Compatibility WMK 1105 / WMK 1110 to predecessor

This document contains additional information about the backward compatibility of the new generation encoders compared to the predecessors WMK-115x / WMK-11x. For discontinuation announcement see customer information #1/2016:

Customer information #9/2016

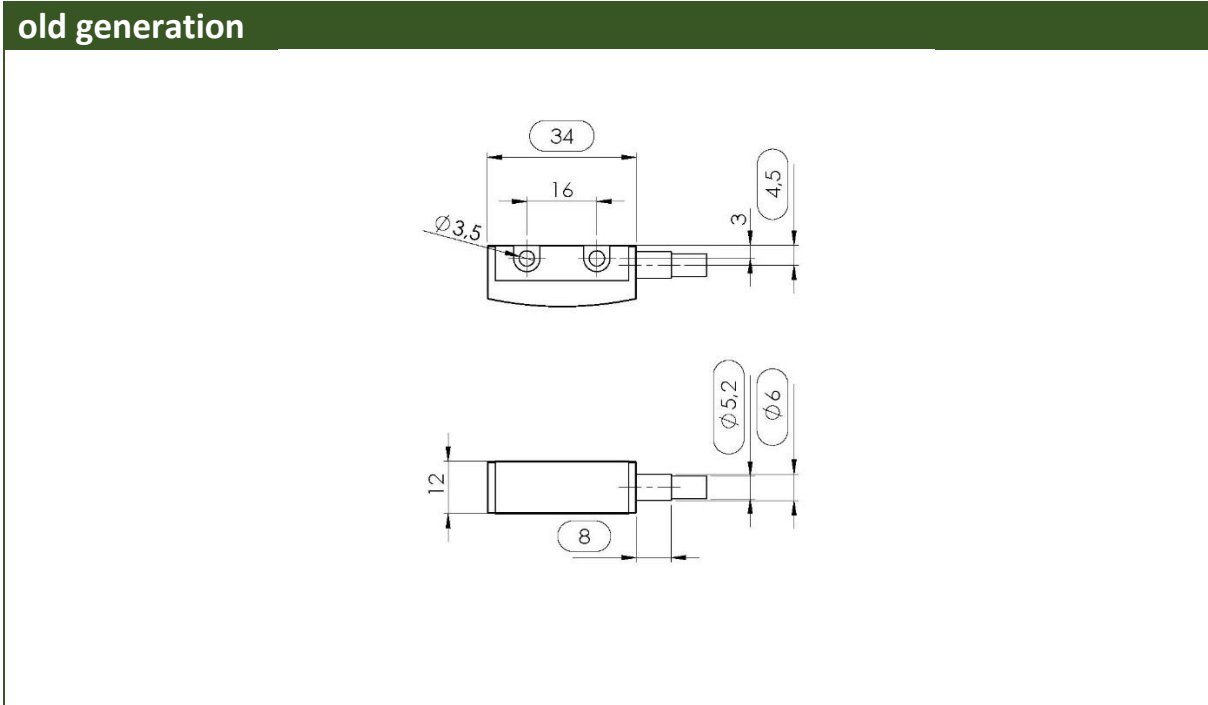
Angle encoders with TTL Interface and an interpolation factor of 1000 (which means a resolution of 0,25 μ m arc length based on a grating period of 1000 μ m) won't show up any more as a price list device.

But there is a backward compatible version available to continue existing applications.

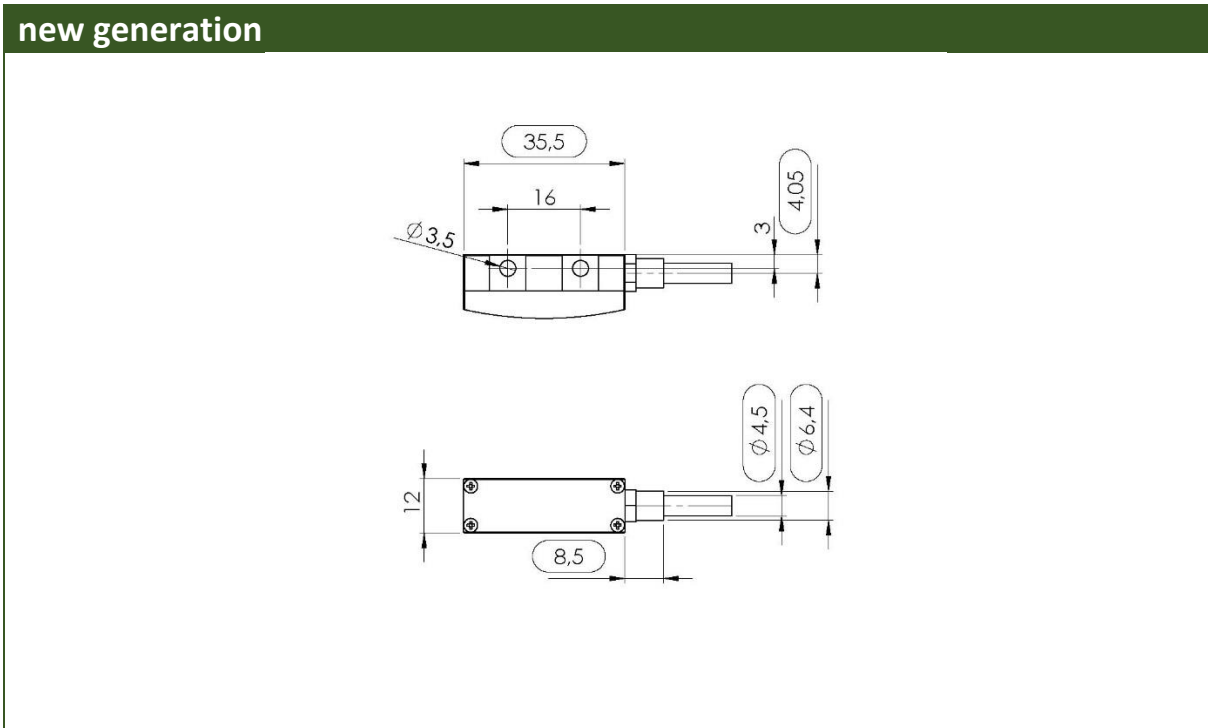
The mechanical dimensions are identical except an improved cable gland (optimizing EMI behaviour) compared to the previous version.

Mechanical dimensions shown in the following drawings. Differences in mechanical dimensions are indicated.
